## V2500-A1/A5/D5 SERIES PROPULSION SYSTEMS SERVICE BULLETIN

This document transmits Revision 4 to Service Bulletin EV2500-72-0166 and Revision 4 to the Supplement

# V2500-ENG-72-0166

ENGINE – DIFFUSER CASE ASSEMBLY – REMOVE THE STAGE 1 HP TURBINE COOLING AIR PRESSURE  
SENSING TUBES

BEFORE AND AFTER VIEWS OF CONFIGURATION CHANGES THAT AFFECT THE DIFFUSER CASE  
ASSEMBLY

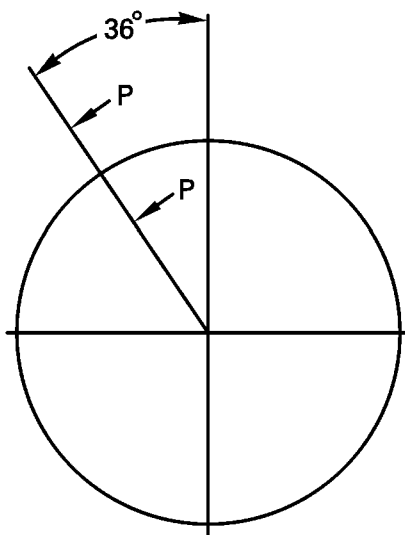
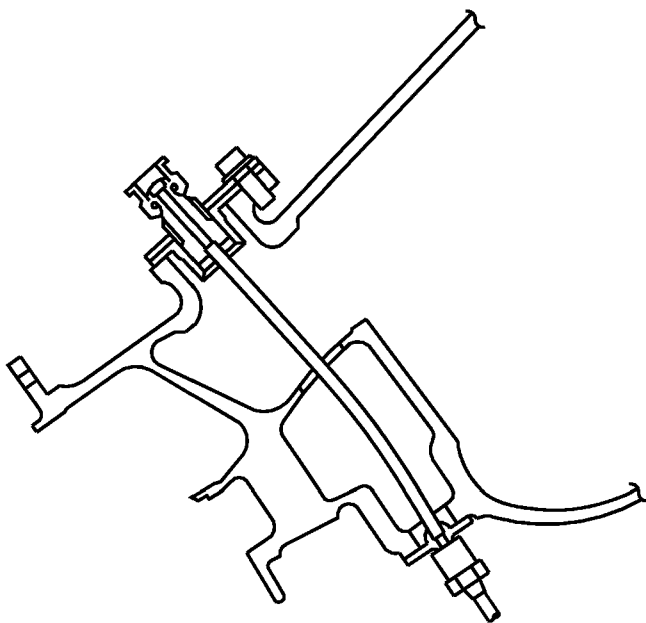
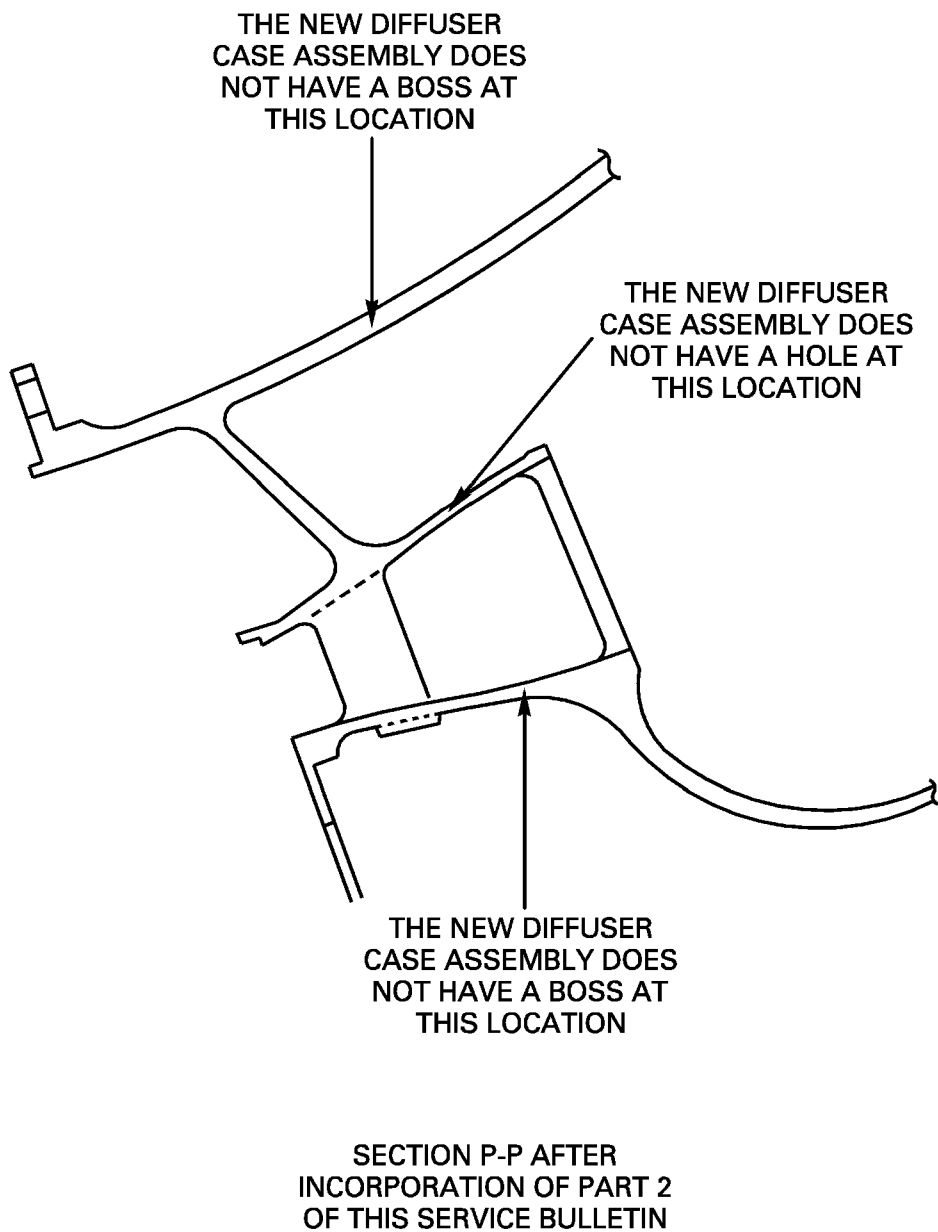
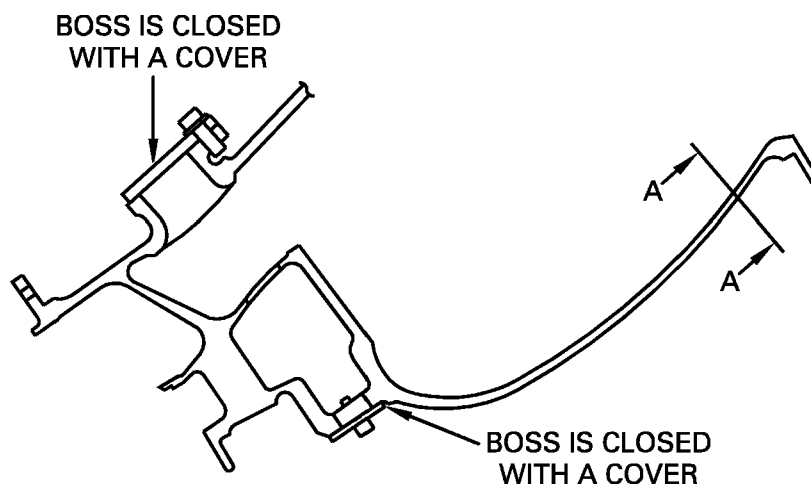
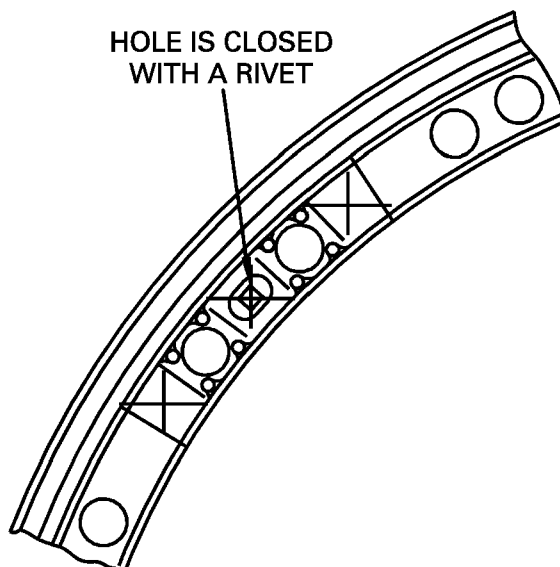
(1) When you install the Diffuser Case Assembly, the Turbine Cooling Duct Airframe Sensing Tube Assembly is not installed again. Refer to Figure 1.

(2) Install the covers and gaskets to close the inner and outer bosses.

(1) A Diffuser Case Assembly, which does not have turbine cooling air pressure sensing tube bosses, is provided for any follow-on spares replacement requirements. Refer to Figure 1.

MODIFICATION OF THE DIFFUSER CASE ASSEMBLY  
Figure 2 (Sheet 1 of 3)

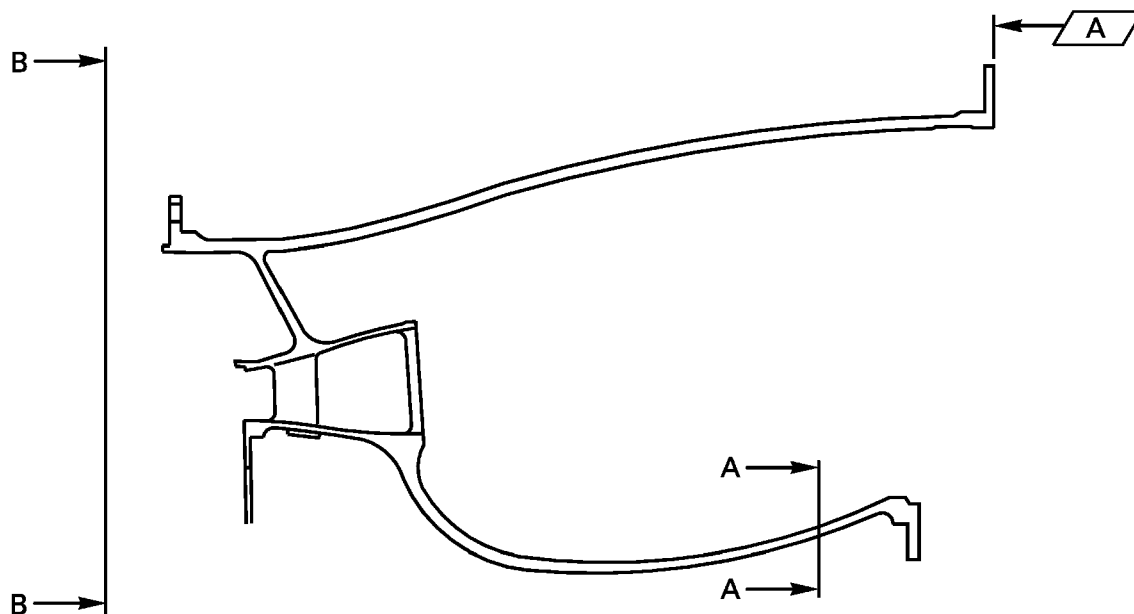
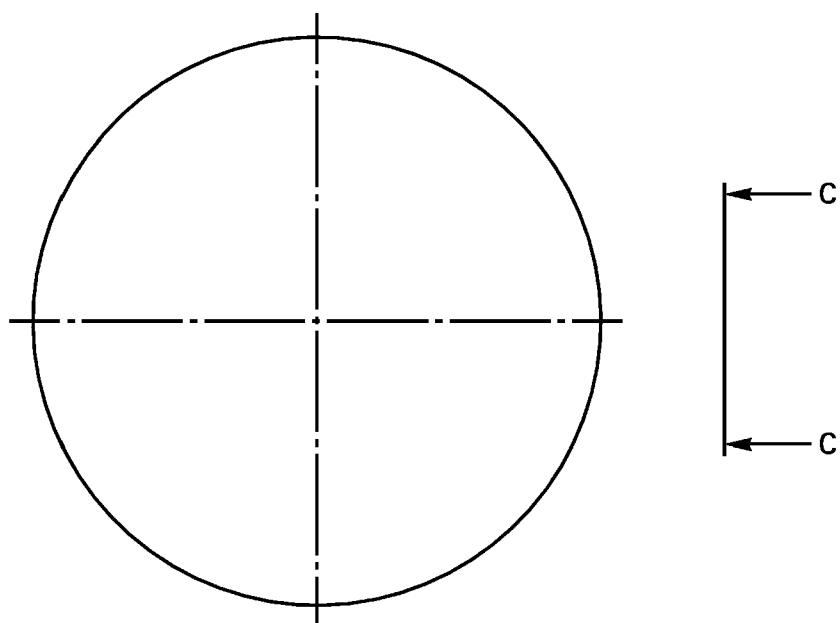
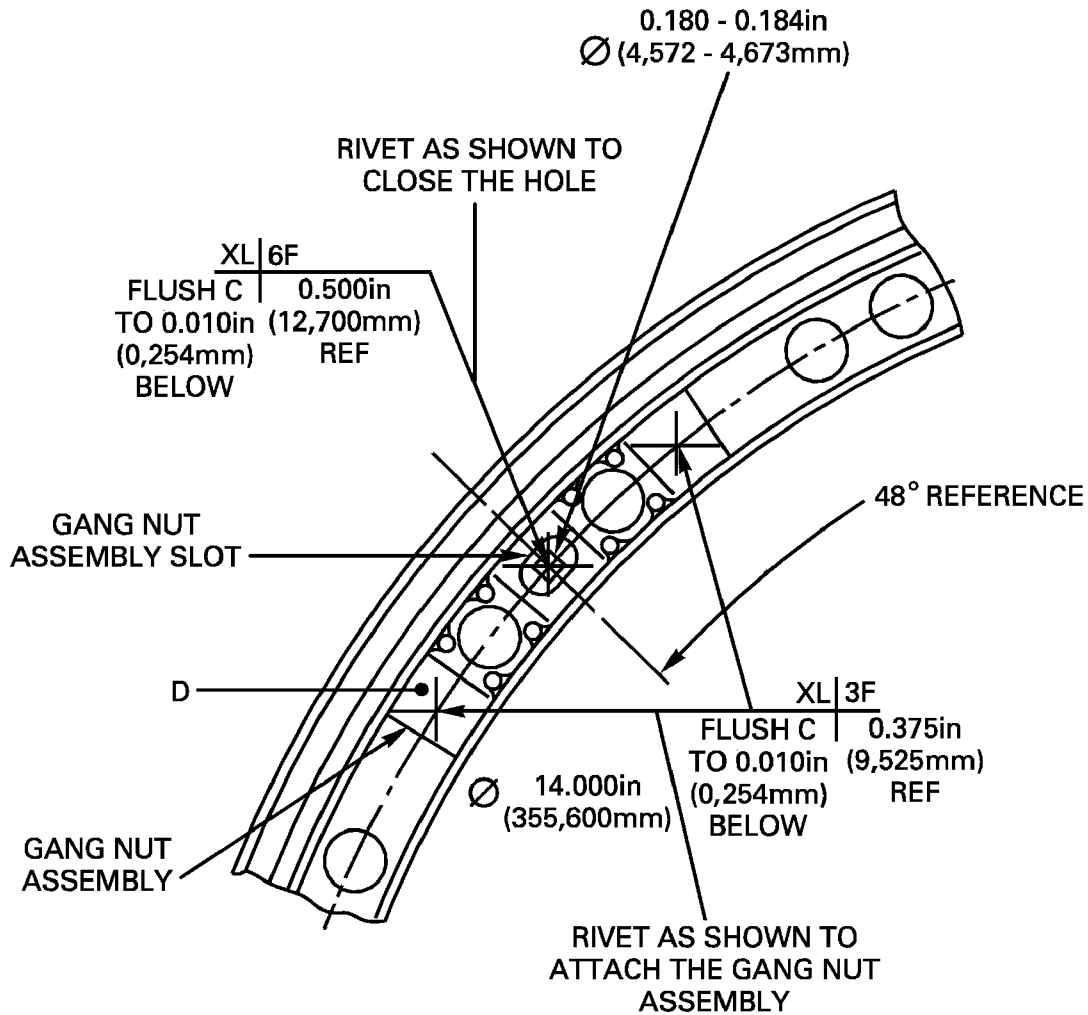
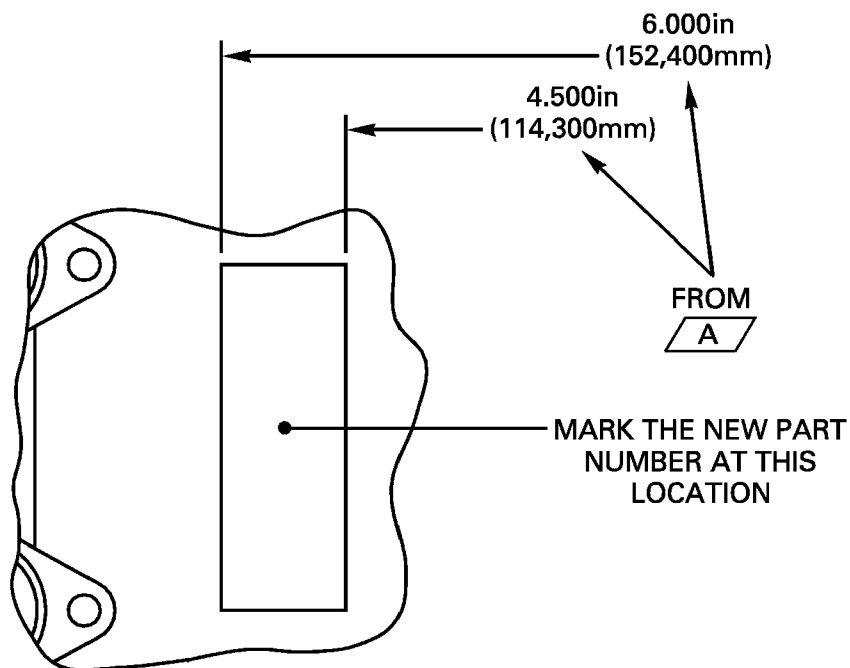
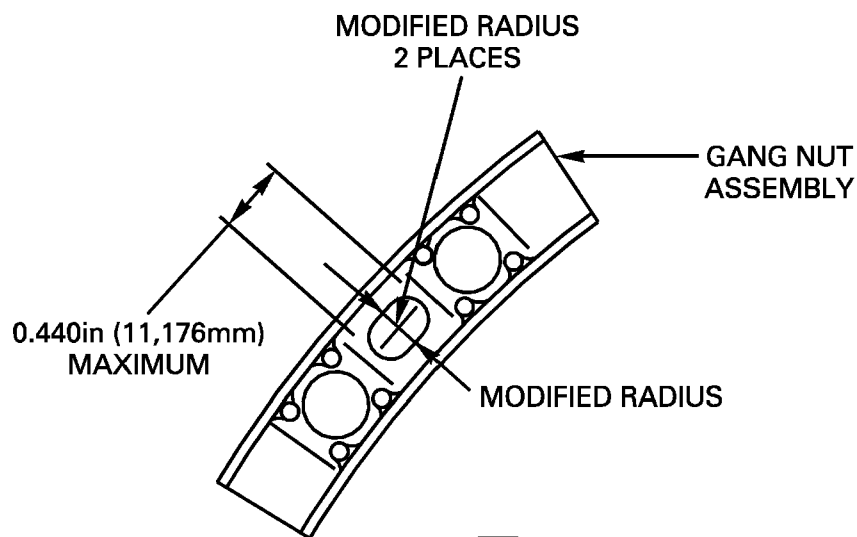
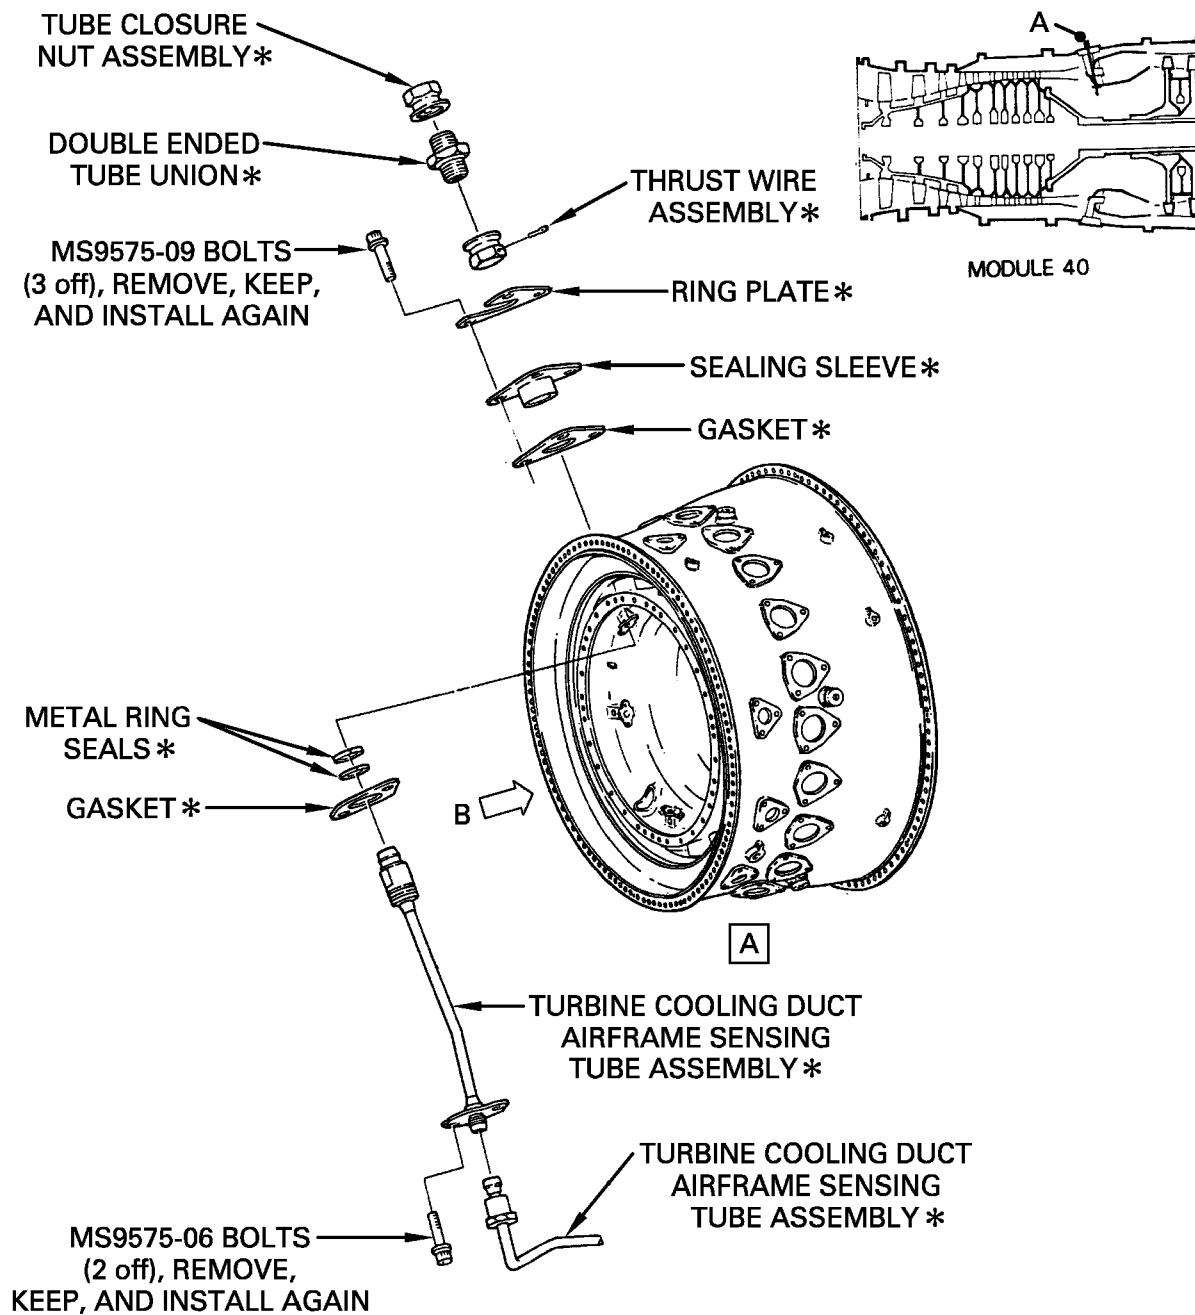
- (1) Do a modification to the 2A0051 or the 2A2581-01 Diffuser Case Assembly (See References (2) and (3) Chapter/Section 72-42-11, Figure No. 01-010) and identify as follows:
  - (a) Remove the rivets that hold the Gang Channel Assembly. Refer to Figure 2.
  - (b) Remove the Gang Channel Nut Assembly. Refer to Figure 2.
  - (c) Close the hole at the specified location with the rivet shown. Refer to Figure 2. See Reference (4), Control No./ TASK No. 70-39-03-390-501.

NOTE: Put the new rivet hole at a location that is in 0.010 inch (0,254 mm) diameter of the hole that is there now.
  - (d) Position the Angle Gang Nut Assembly so that the rivet holes align with the holes in the case flange.

- (i) Do not install the rivets at this time.
  - (e) Do a check of the clearance between the upset head of the rivet and the slot in the Gang Nut Assembly. Refer to Figure 2.

- (i) If there is sufficient clearance install the rivets by step F.
    - (ii) If there is not sufficient clearance hand grind the slot to the dimensions given. Refer to Figure 2.

- (f) Install the Gang Channel Nut Assembly on the Diffuser Case Assembly flange with the rivets shown. Refer to Figure 2. See References (4) Control No./TASK No. 70-39-03-390-501.

- (g) Mark the new part number adjacent to the old part number. Use the vibration peen method. See Reidentified Parts Data for part numbers. Also see Reference (4), Control No./TASK No. 70-09-00-400-501. Refer to Figure 2.

LOCATION OF THE TURBINE COOLING DUCT AIRFRAME SENSING TUBE ASSEMBLY  
Figure 3 (Sheet 1 of 2)

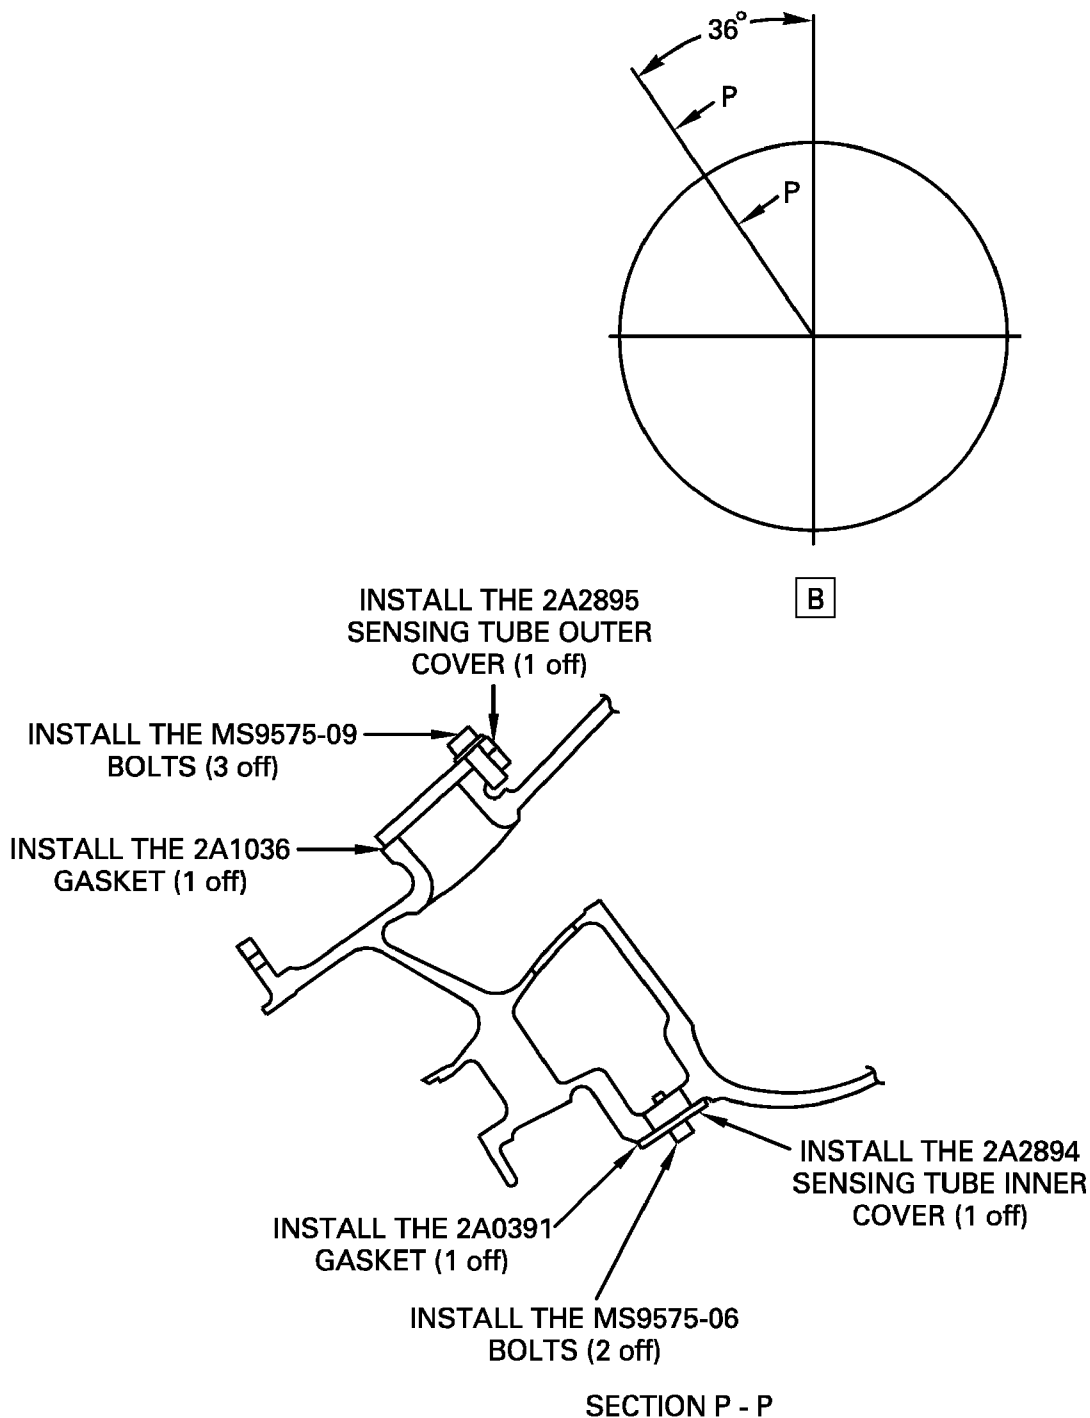
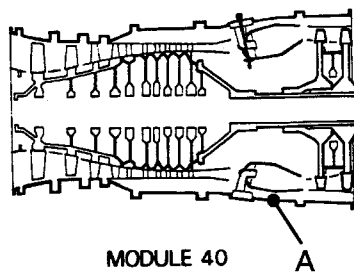
(a) When you assemble the Diffuser Case Assembly and fittings by the procedure given in Reference (2), Chapter/Section 72-42-10, Assembly, do not install the Turbine Cooling Duct Airframe Sensing Tube Assembly. Refer to Figure 3.

(b) Install the 2A2894 Sensing Tube Inner Cover by Figure 3 and as follows:

- (i) Install the cover on the boss at the location shown in the diffuser case inner diameter.
- (ii) Make sure that the bolt holes in the cover are in line with the bolt holes in the Diffuser Case Assembly.
- (iii) Lubricate the MS9575-06 Bolts (2 off) with CoMat 10-077 Approved Engine Oils.
- (iv) Install the MS9575-06 Bolts (2 off) in to the two bolt holes.
- (v) Tighten the bolts with your hand.
- (vi) Torque the bolts to between 65 to 85 lbfin (7,344 to 9,604 nm).
- (vii) Safety the bolts with CoMat 02-141 Lockwire.

(c) Install the 2A2895 Sensing Tube Outer Cover by Figure 3 and as follows:

- (i) Install the cover on the boss at the location shown on the diffuser case outer diameter.
- (ii) Make sure that the bolt holes in the cover are in line with the bolt holes in the Diffuser Case Assembly.
- (iii) Lubricate the MS9575-09 Bolts (3 off) with CoMat 10-077 Approved Engine Oils.
- (iv) Install the MS9575-09 Bolts (3 off) in to the three bolt holes.
- (v) Tighten the bolts with your hand.
- (vi) Torque the bolts to between 65 to 85 lbfin (7,344 to 9,604 nm).
- (vii) Safety the bolts with CoMat 02-141 Lockwire.

(a) When you assemble the Diffuser Case Assembly and fittings by the procedure given in Reference (3), Chapter/Section 72-42-10, Assembly, do not install the Turbine Cooling Duct Airframe Sensing Tube Assembly. Refer to Figure 3.

(b) Install the 2A2894 Sensing Tube Inner Cover by Figure 3 and as follows:

(c) Install the 2A2895 Sensing Tube Outer Cover by Figure 3 and as follows:

REPLACEMENT OF THE DIFFUSER CASE ASSEMBLY – PART 2 (WITH A CASE ASSEMBLY THAT DOES NOT HAVE BOSSES FOR THE TURBINE COOLING AIR SENSING TUBE)

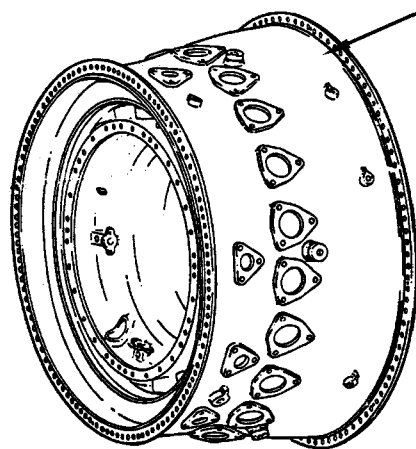
(i) Install the Diffuser Case Assembly and fittings by the procedure given in Reference (2), Chapter/Section 72-42-10, Assembly. Refer to Figure 4.

(ii) The parts which follow will not be installed with the new configuration:

Part Number	Description
2A2894	Inner Sensing Tube Cover (1 Off)
2A2895	Outer Sensing Tube Cover (1 Off)
MS9575-09	Bolt (3 Off)
2A1036	Gasket (1 Off)
2A0391	Gasket (1 Off)
MS9575-06	Bolt (2 Off)

(i) Install the Diffuser Case Assembly and fittings by the procedure given in Reference (2), Chapter/Section 72-42-10, Assembly. Refer to Figure 4.

- (a) When it is necessary you can replace the 2A2897-01 Diffuser Case Assembly with the 2A2891-01 Diffuser Case Assembly.
- (i) Install the Diffuser Case Assembly and fittings by the procedure given in Reference (3), Chapter/Section 72-42-10, Assembly. Refer to Figure 4.
- (ii) The parts which follow will not be installed with the new configuration:

- (a) When it is necessary you can replace the 2A2581-01 Diffuser Case Assembly with the 2A2897-01 Diffuser Case Assembly.
- (i) Install the Diffuser Case Assembly and fittings by the procedure given in Reference (3), Chapter/Section 72-42-10, Assembly. Refer to Figure 4.
- (ii) The parts which follow will not be installed with the new configuration:

FOR THE V2500 - A5 AND  
THE V2500 - D5 ENGINE MODELS  
INSTALL THE 2A2891 - 01 DIFFUSER  
CASE ASSEMBLY

FOR THE V2500 - A1  
ENGINE MODEL INSTALL  
THE 2A2889 - 01 DIFFUSER  
CASE ASSEMBLY
